Job No. 188050

March 18, 2022
Amended January 10, 2023

Re: Wastewater Study
Mountain Rd
Guntzelman Porcelain Pines Subdivision
El Paso County, Colorado

FIG No. 2

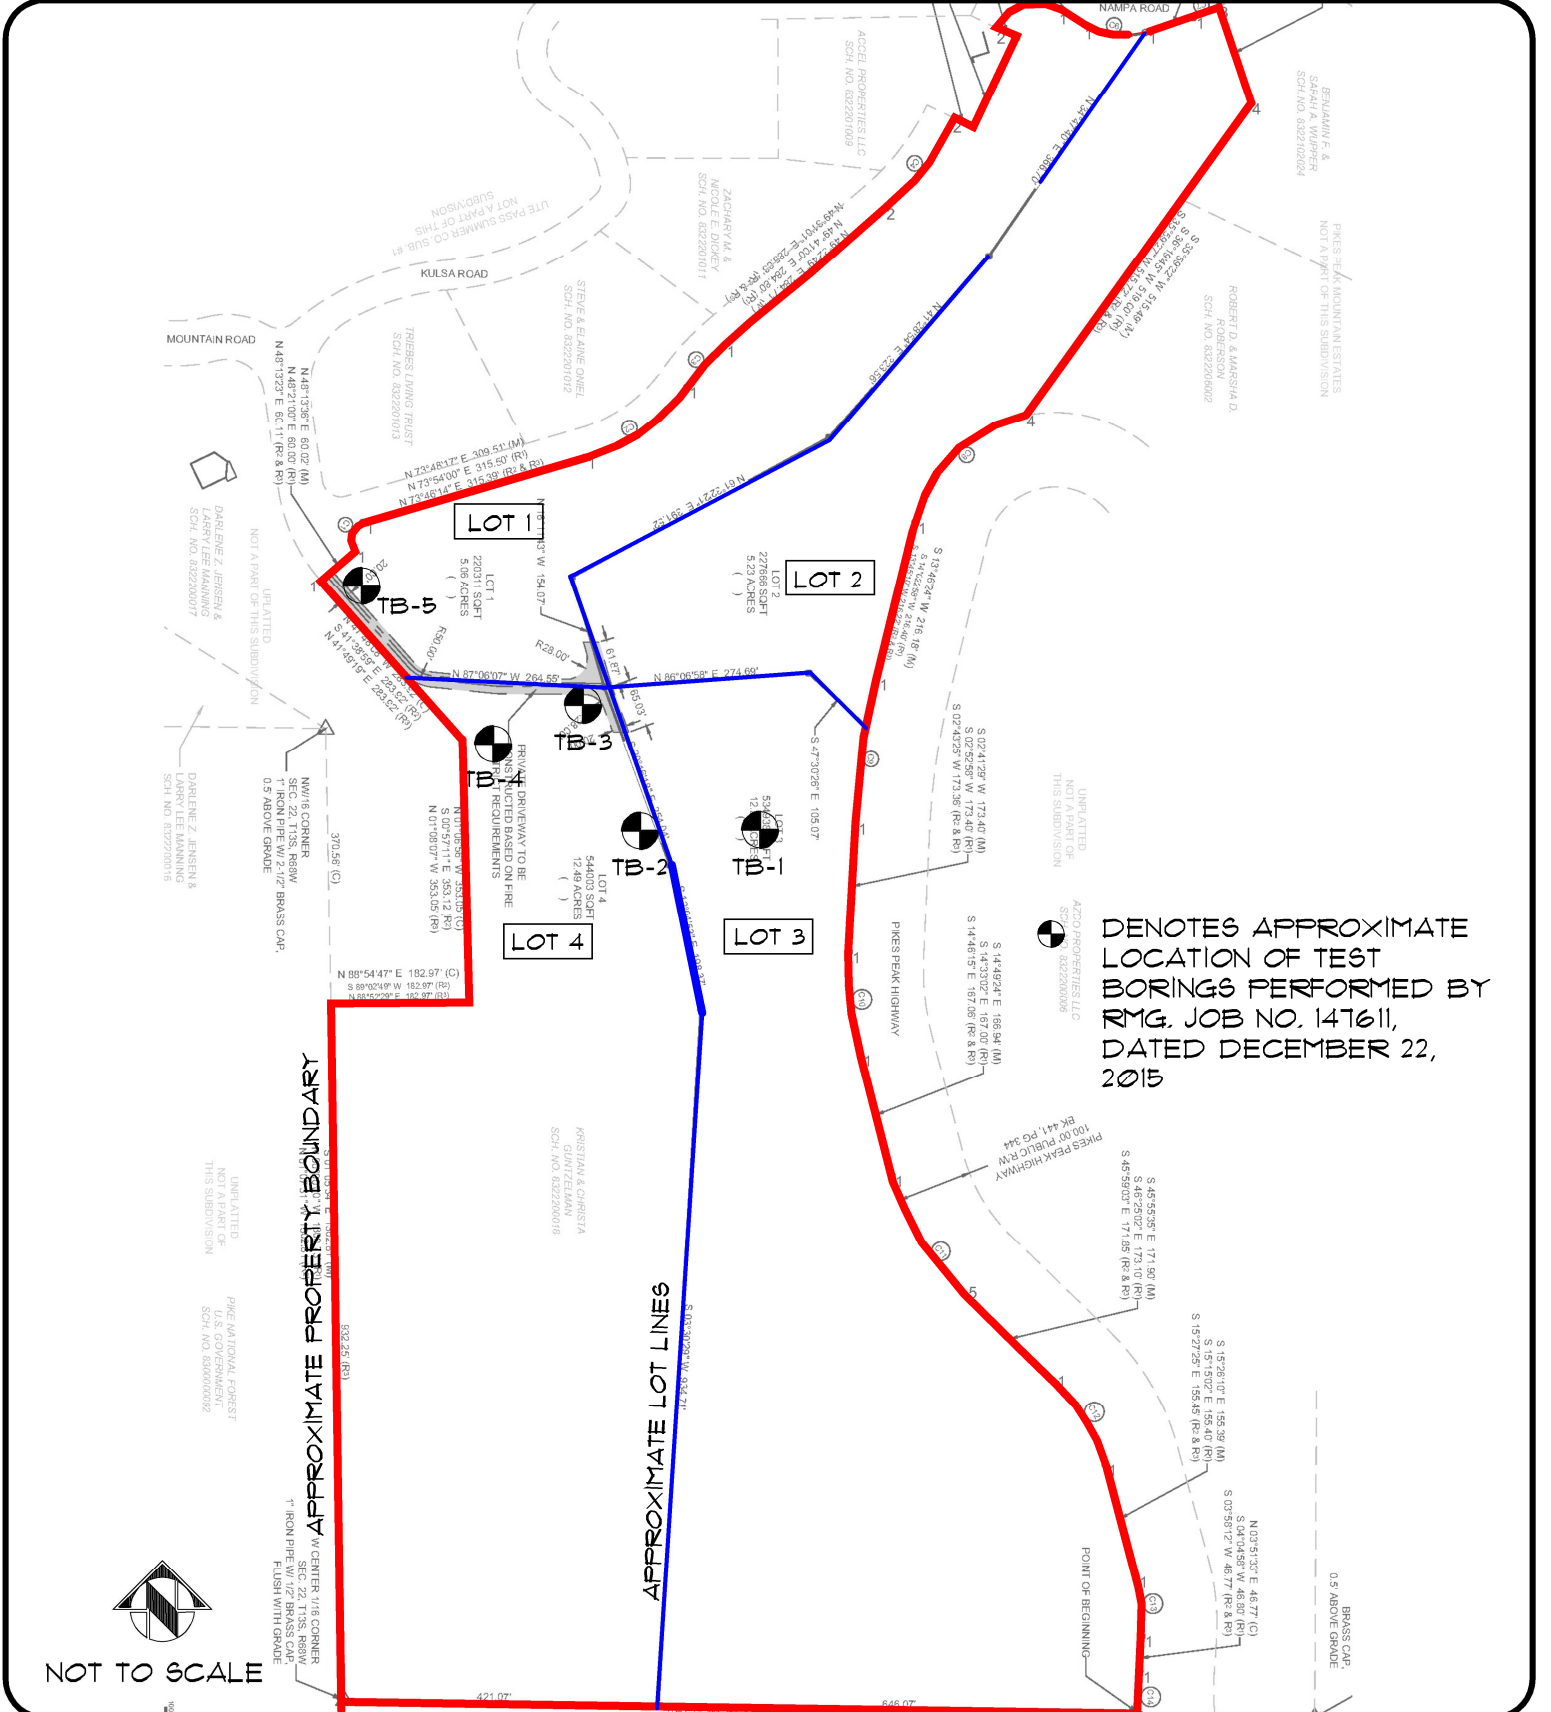
Comments have been provided on
Figure 2 map sheet.

FIG No. 4

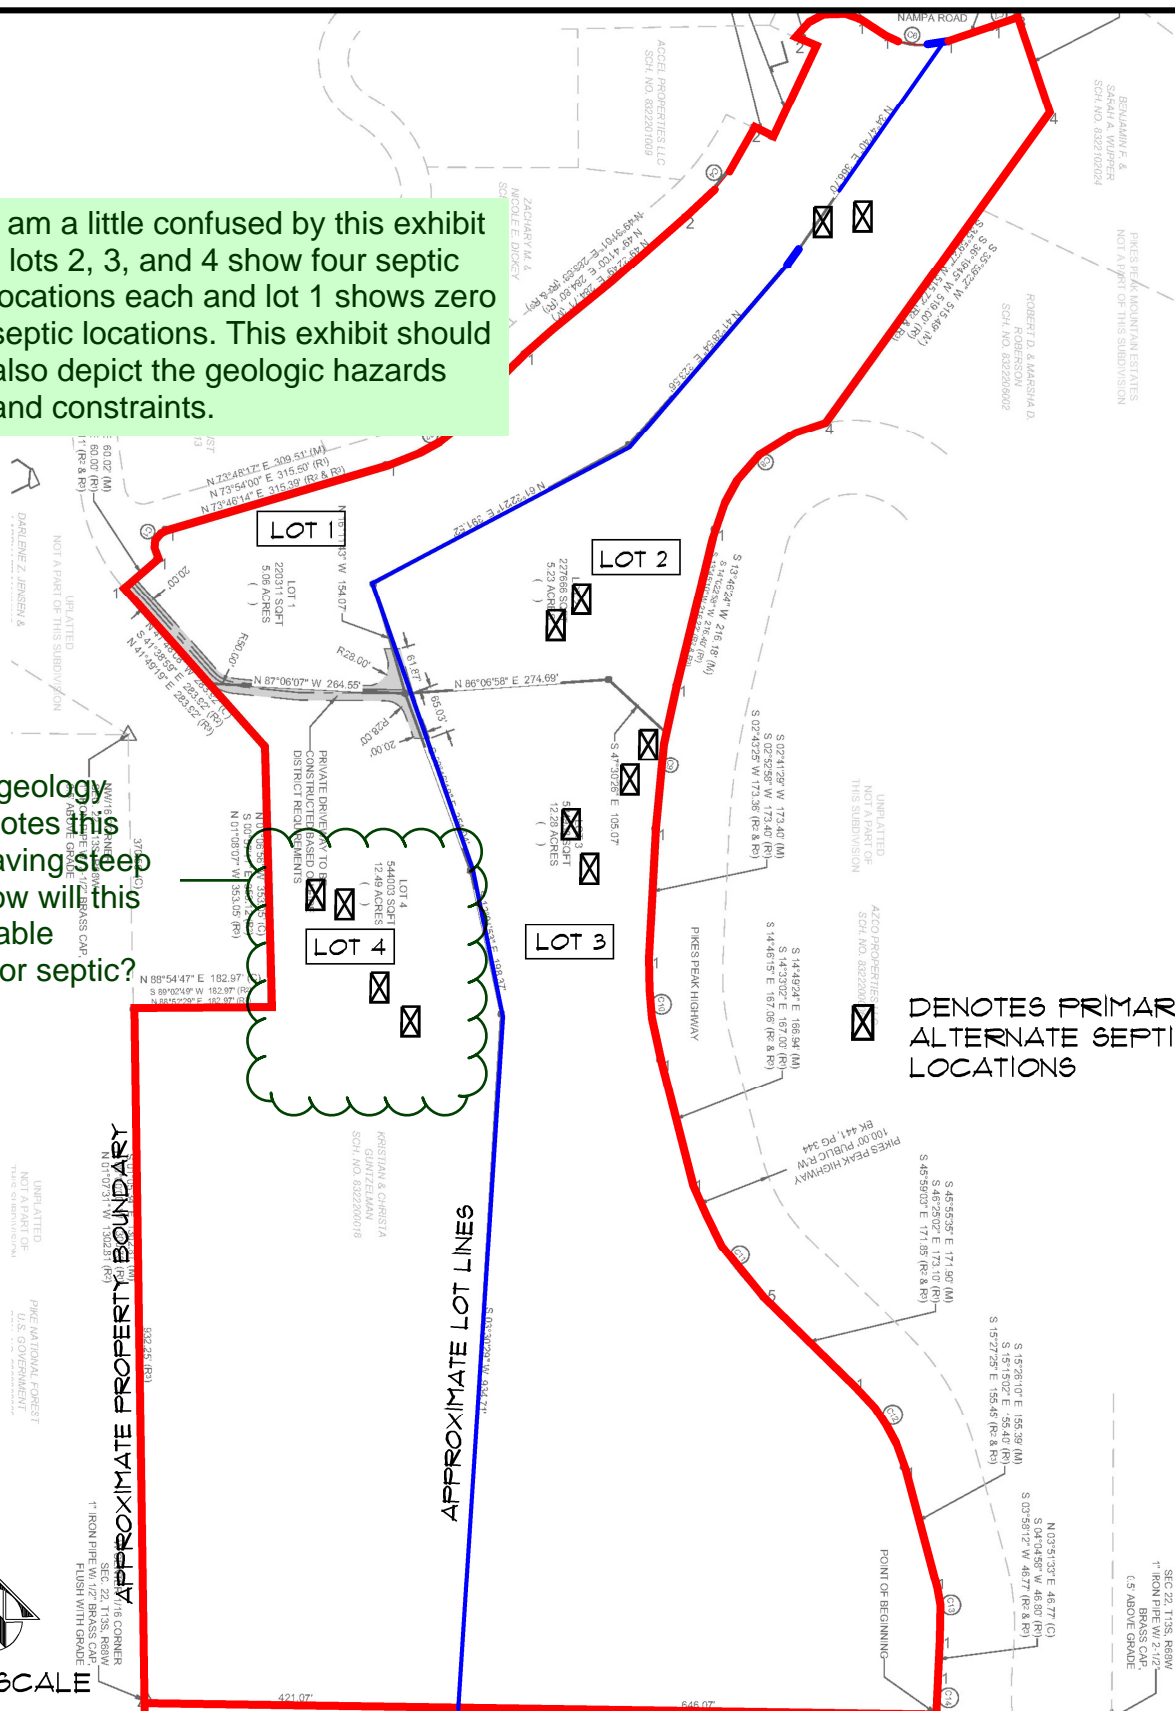
I am a little confused by this exhibit - lots 2, 3, and 4 show four septic locations each and lot 1 shows zero septic locations. This exhibit should also depict the geologic hazards and constraints.

Soils and geology report denotes this area as having steep slopes. How will this be acceptable locations for septic?
